Doc.-No. 017B.16.002

LAK-17B/BT/B FES flap handle

1.2 Reason

To loose flap handle fixation due to the wear of the handle.

Illustration 1. Inspection the flap handle

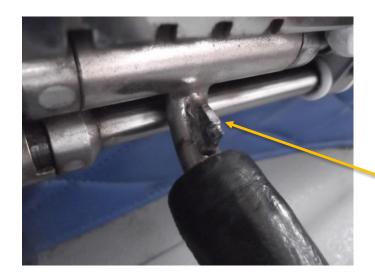
Inspect the flap handle fixing element from being damaged. Check if there is no any deformation or wear signs, which could lead to a loose handle fixation (illustration 1). In cases the flap handle isn't fixing properly, you need to change the handle and the flap plate (see the instruction below).

Damaged flap handle fixing element

Illustration 3. Changing the flap handle

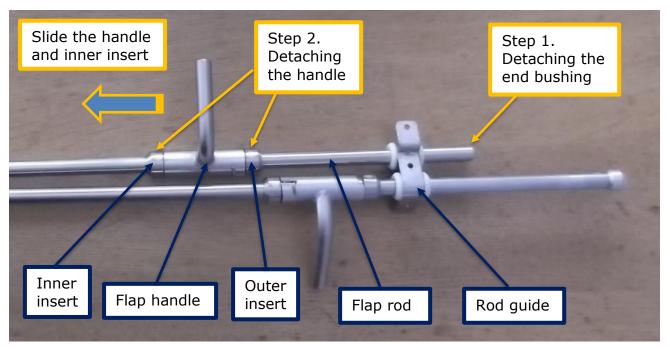
3.3 Modification (changing the flap handle – illustration 3)

- 1) Drill out solid rivet (ø3.5mm) and remove the end bushing from the flap rod. Clean the holes from the scrap.
- 2) Drill out solid rivets (ø3.5mm) through the inserts and detach the flap handle. Move out the flap rod from the guide. Remove the outer insert and slide the flap handle with inner insert to the opposite side to make possible detach the torsion spring. Remove the spring, handle and the inner insert. Clean the rivet holes from the scrap.

- 3) Slide back the inner insert with the new handle (LAK-17B 55 01 06 01 10 SB). Attach the new torsion spring (LAK-17B 55 01 00 02) fixing the inner end of the spring in the hole in the rod.

- 4) Slide the handle back to its position and attach the torsion spring fixing the outer end in the handle slot.
- 5) Slide back the inner and outer handle inserts to their positions. Match the holes with the holes in the rod. Rivet the inserts with rivets (3531A-3.5-24). File the rivet heads to match the surfaces of the inserts.

- 6) Move the flap rod through the guide and attach the end bushing matching the rivet holes. Rivet the bushing with rivet (3531A-3.5-16). File the rivet heads to match the surfaces of the bushing.

Illustration 4. Changing the flap plate

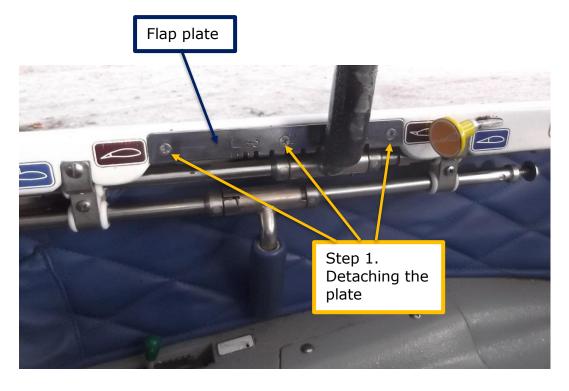
3.4 Modification (changing the flap plate – illustration 4)

- 1) Unscrew three M4 screws and remove the flap plate.
- 2) Fit the new plate (LAK-17B 55 01 00 02) and screw it.
